In re application of	)	
	)	
Blatter	)	
	)	
Serial No.:	)	Art Unit
	)	3761
Filed:	)	
	)	
For:	)	
	)	APPARATUS AND METHODS FOR
	)	FACILITATING REPEATED VASCULAR ACCESS
	)	
Examiner:	)	Leslie R. Deak
	)	
Patent No.:	)	7,118,546 B2
	)	
Issue Date:	)	October 10, 2006

REQUEST FOR A CERTIFICATE OF CORRECTION  
UNDER 37 C.F.R. § 1.323

**CERTIFICATE OF CORRECTION**

PATENT NO. : 7,118,546 B2  
DATED : October 10, 2006  
INVENTOR(S): Blatter

**Fig. 11B**

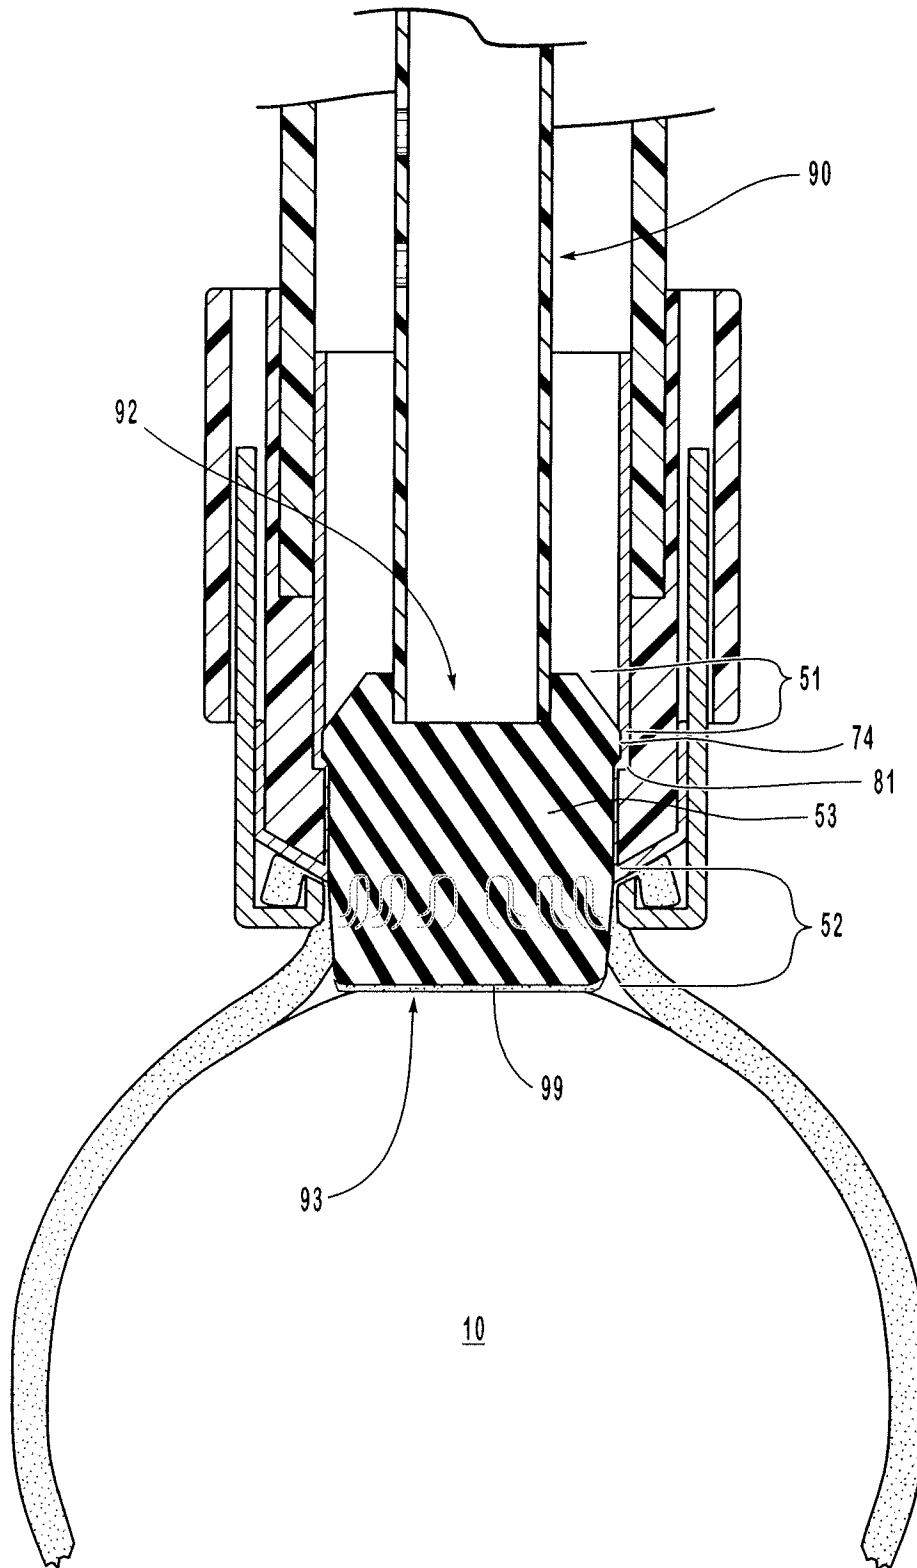
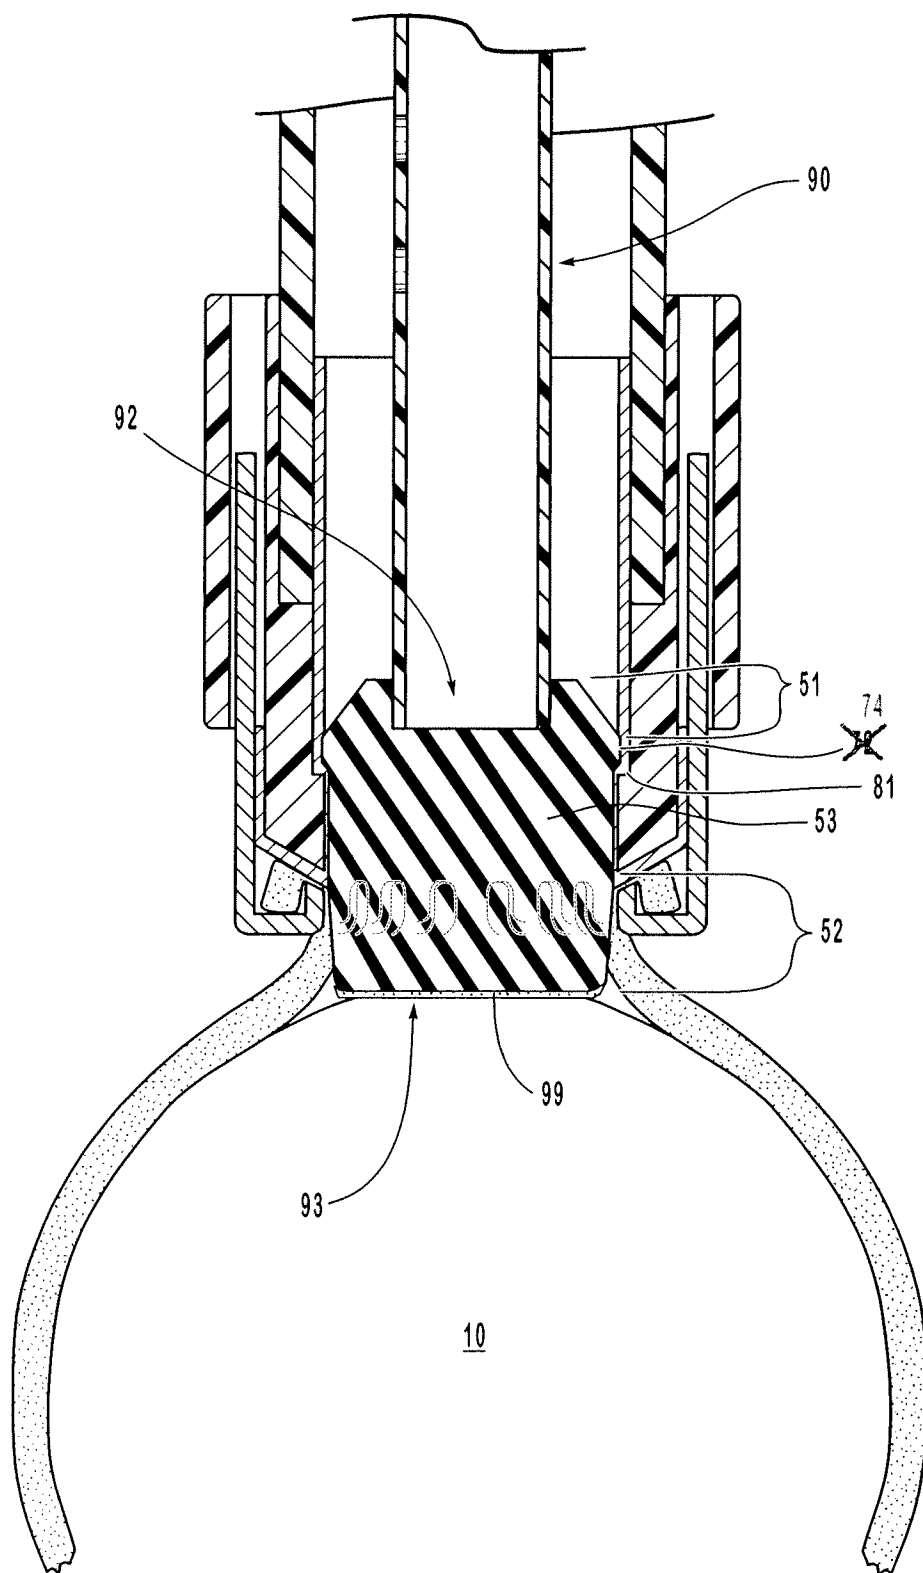
In accordance with the provisions of 37 C.F.R. § 1.323 which implement 35 U.S.C. § 255, the Commissioner is respectfully requested to issue a Certificate of Correction to correct mistakes in the above-identified patent. The enclosed Patent Office Form 1050 reflects the desired corrections. Note that attached are replacement sheets for drawing sheets 17 and 27,

including annotated copies of the original drawing sheets. The changes are to correct numbering mistakes.

**Drawing sheets 17 and 27 have been replaced with the attached replacement sheets.**
